# NP/10/541

## Lower Dale Hill, Dale

**Application Type:** Listed Building  
**Reference:** 10/541 Grid Ref. SM806063  
**Applicant:** Mr & Mrs G Potter & Brett-Jones,  
**Agent** Ms Deacon  
**Proposal:** Minor alterations  
**Site Location:** Lower Dale Hill, Dale

Drawing: ldh/window detail  
 16.12.10

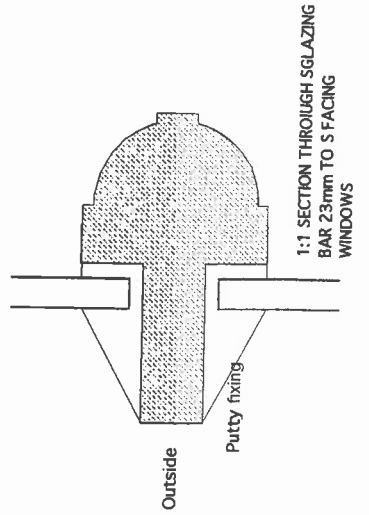
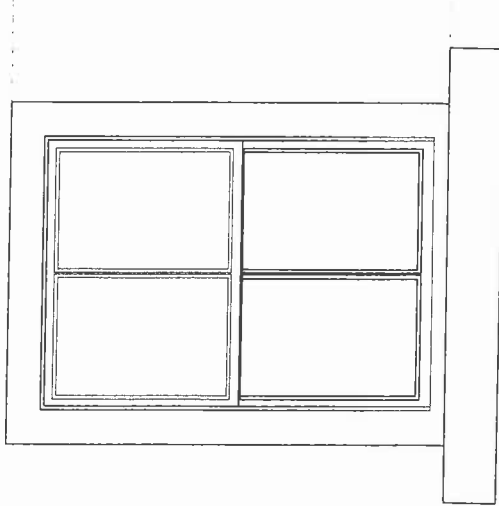
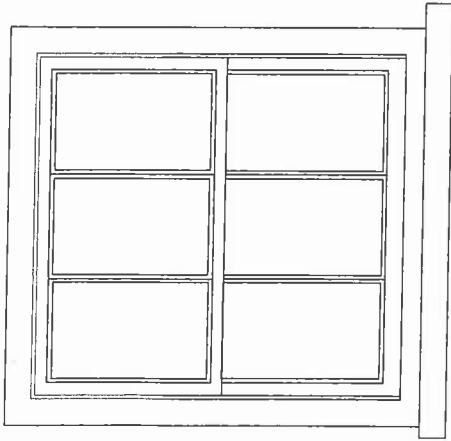
The replacement of the modern sash windows is also considered acceptable, offering the opportunity to replace modern windows with more appropriately designed four-pane timber sash ones. This would benefit the character and appearance of the Listed Building, particularly on the south elevation. However, the replacement of the modern windows on the north elevation is to be with double-glazed timber sashes. Although the applicant has proposed as narrow glazing beads as possible, the provision of double-glazed sealed units into Listed Buildings is contrary to national guidance due to its detrimental impact on the character and appearance of the Listed Building.

Windows form one of the most significant constructional elements of any building, and their style and proportion vitally affect the character and appearance of elevations. Government guidance goes on to advise that "It is usually impossible to install double-glazed sealed units in existing frames or to replicate existing frames with new sealed units without making drastic changes to the shape or proportions of glazing bars. Although they have been proposed in order to minimise heat loss, national guidance is clear that there are other alternatives to double-glazed sealed units to make the building as sustainable as possible. The applicant has sought to minimise the visual impact of the double-glazing, but the noticeable changes that its installation would have on the building is considered detrimental to the special architectural and historic quality of this Grade II Listed Building. As a result this forms a reason for refusal.

However, the applicant has challenged the grounds of this refusal and cites the approval of double glazed windows on other properties in the National Park. The Conservation Officer is considering the application in light of it proposing slim line double glazing, and is also asking CADW for its views, particularly in light of the requirement for maximising the sustainability of buildings. An update on these matters will be given at the meeting.

1. Policy 1 of the Pembrokeshire Coast National Park Local Development Plan requires, amongst other things, development within the National Park to conserve or enhance the cultural heritage of the area. Policy 8 of the Pembrokeshire Coast National Park Local Development Plan requires the protection of the special qualities of the National Park, and amongst other things, seeks to ensure that the historic environment is protected and enhanced where possible. Policy 15 of the Pembrokeshire Coast National Park Local Development Plan requires new development to not adversely affect the qualities and special character of the National Park. The insertion of replacement double-glazed windows is an unsympathetic modern addition to this Grade II Listed
